SUBJECT: Forwards Attachment 1 Rev 1 to pending exemption request  
 from App R,Section III.G.2 re proposed mods to component  
 cooling water pump room.Changes involve addition of partial  
 area suppression.

H. B. ROBINSON STEAM ELECTRIC PLANT, UNIT NO. 2  
DOCKET NO. 50-261/LICENSE NO. DPR-23  
FIRE PROTECTION  
CCW PUMP ROOM EXEMPTION REQUEST

### H. B. Robinson Unit No. 2 Additional Information On Pending Exemption Request

#### Component Cooling Water Pump Room

Figure 1 ELEVATION OF COMPONENT COOLING WATER AREA

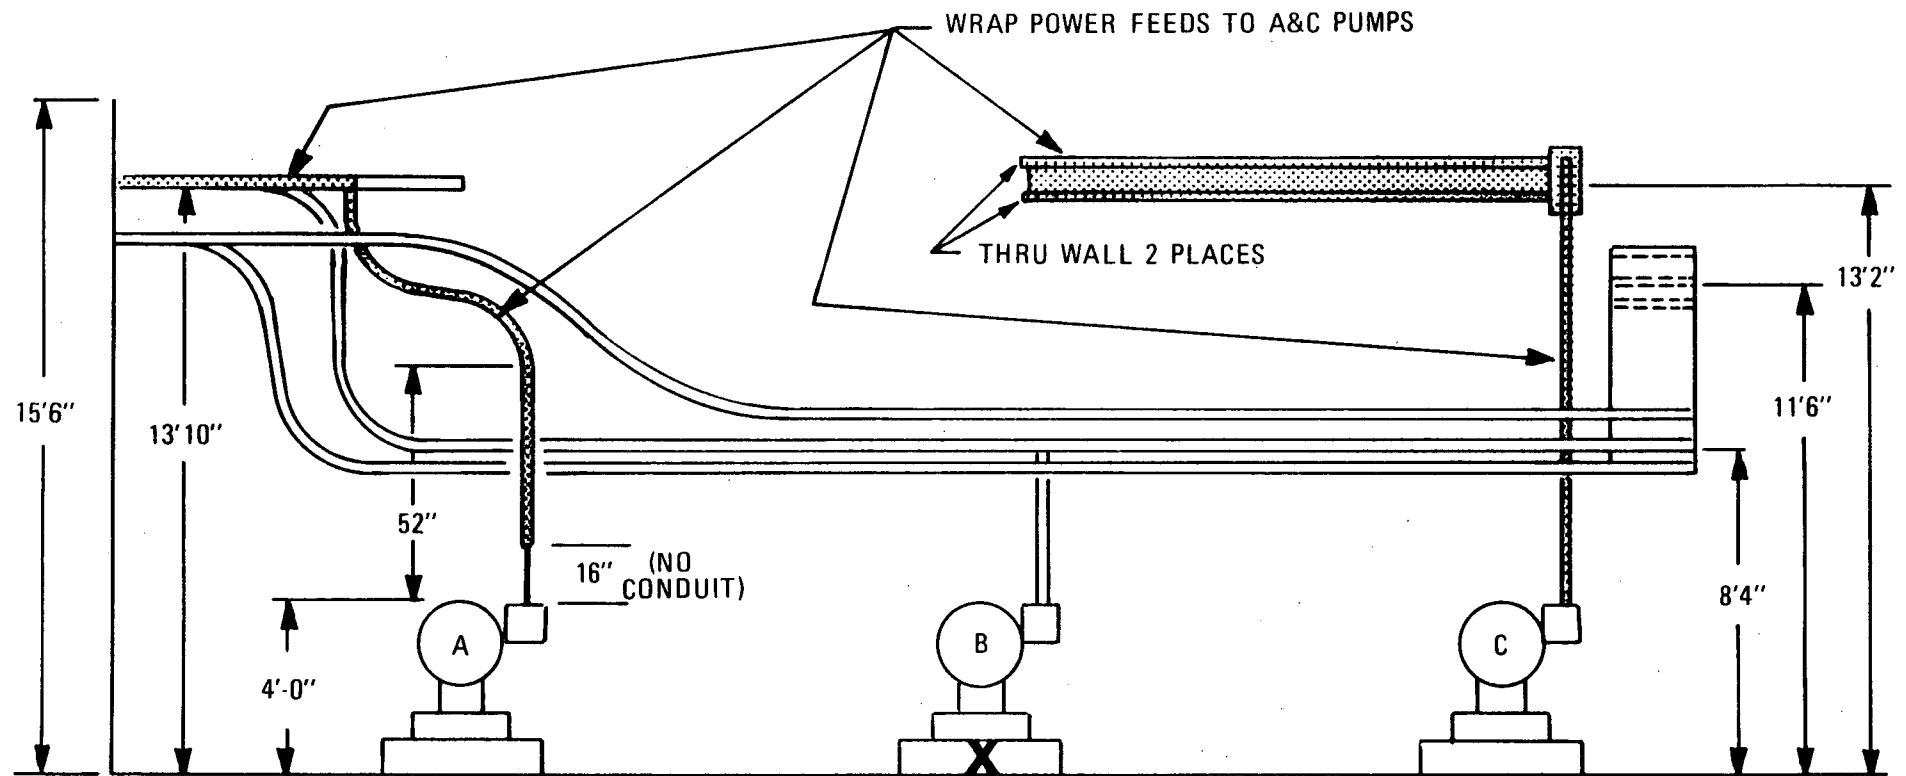
The pump power supply cables for component cooling water pumps A and C are installed in conduit (Photographs 1, 2, 4-7). The pump A power cable currently is routed through conduit which empties into a tray. Power cables for both pumps are horizontally separated by 12 ft with the highest tray located 13 ft 10 in off the floor (Figure 1).

NOTE: POWER FEEDS TO PUMP "A" CURRENTLY IN TRAY  
TO BE REROUTED IN CONDUIT AND WRAPPED.

**Figure 2 PLAN OF COMPONENT COOLING WATER AREA**

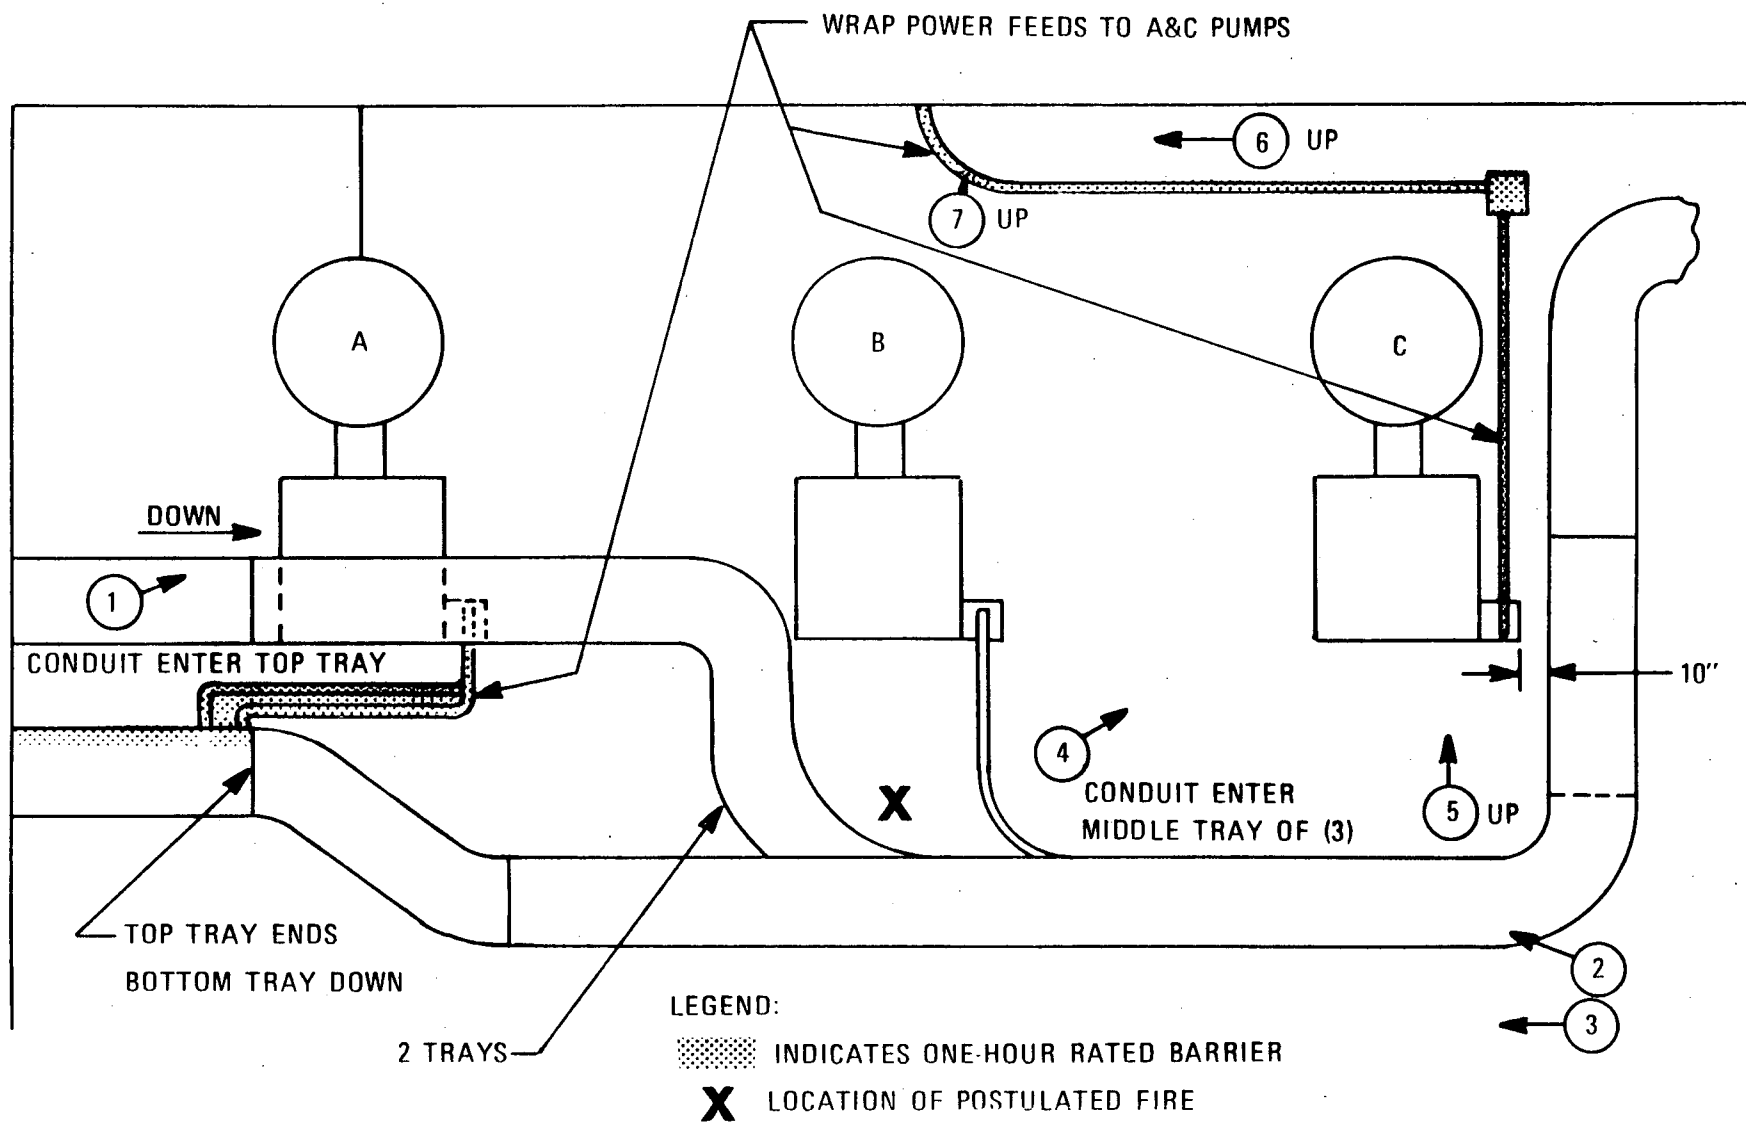
In order to maximize the impact of a postulated exposure fire on the redundant pumps A and C, the transient combustible materials are assumed to be located directly in front of pump B, equidistant between the pumps (Figure 2). This location allows for radiation from the flames to directly impact both pumps simultaneously. An analysis of the effects of a fire is performed (Appendix A) which assumes that all radiant energy from the exposure fire will be viewed by the pump motor casings with no re-radiation to other energy-absorbing materials in the area and no natural convection to remove energy from the pump casings. The fire brigade would respond immediately for a fire in this area, nevertheless, the proposed suppression system would automatically actuate and suppress the fire.

NOTE: POWER FEEDS TO PUMP "A" CURRENTLY IN TRAY  
TO BE REROUTED IN CONDUIT AND WRAPPED.

Figure 3 COMBUSTIBLE LOADING CONFIGURATION IN COMPONENT COOLING WATER AREA

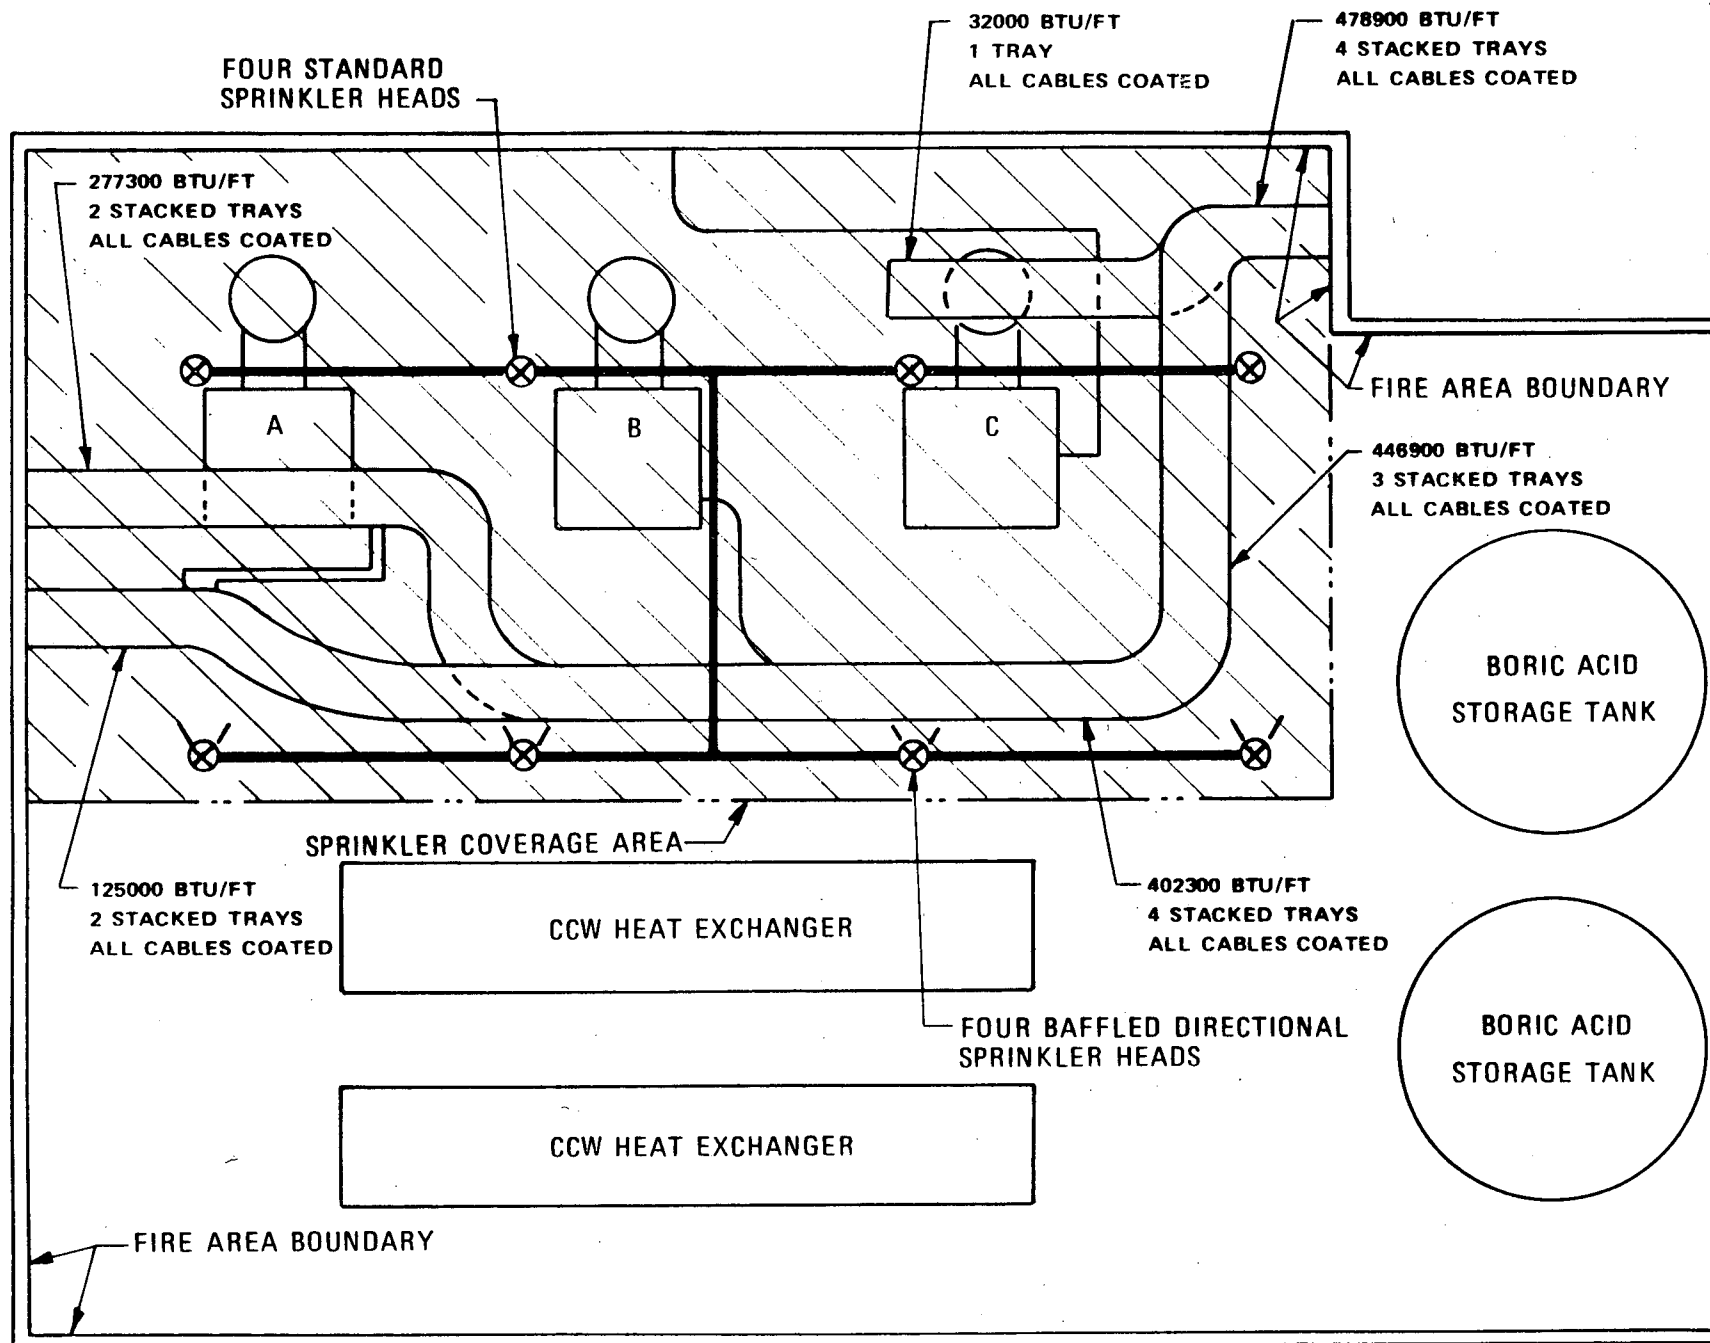
Changes to the attachment are indicated by vertical bars in the right-hand margins. Briefly, the changes involve the addition of the partial area suppression (refer to Figure 3) along with our proposal to delete the previously-proposed plume-impingement barrier beneath Balance of Plant cable trays in the area and our intention to remove the existing radiant heat shield wall adjacent to CCW Pump A.

To enhance the protection of the component cooling water pump room and preclude ignition of the power cables to both pumps A and C, CP&L proposes to provide a one (1) hour barrier around the power supply cables for pumps A and C. In addition, a partial fire suppression system will be installed in the area of the component cooling water pumps and the aisle in front of the pumps. (See Figure 3.)<sup>1/</sup>

A preaction sprinkler system will be hydraulically designed to meet the requirements of NFPA 13-1983 with respect to density and area of coverage. The occupancy is considered to be "Ordinary Hazard, Group 1."

Item	Value	Source
a. Area Classification	Ordinary Hazard (Group 1)	NFPA 13, 1-7.3.1
b. Area of Application	860 sq. ft.	NFPA 13, 2-2.1.2
c. Density of Water Application	0.16 GPM/ft <sup>2</sup>	NFPA 13, 2-2.1.2.8 and Figure 2-2.1B
d. Max. Area Coverage Per Sprinkler	130 ft <sup>2</sup>	NFPA 13, 4-2.2.2
e. Number of Sprinkler Heads	8 minimum	NFPA 13, 4-2.2.2

Item		Value	Source
f.	Maximum Distance Between Sprinkler Head Branch Lines	15 feet	NFPA 13, 4-2.1.2
g.	Maximum Distance of Branch Line from Wall	7½ feet	NFPA 13, 4-2.1.2
h.	Height of Sprinkler Head Below Ceiling	1" to 18"	NFPA 13, 4-3.4.1
i.	Seismic Requirements	DBE (acceleration = 1.51 g at elevation 246)	UFSAR Sections 3.2 and 3.7.3
j.	Sprinkler Heads	U.L. Listed, ½" orifice, 165°F (Grinnell Pt. No. SSU-3 or equal)	---
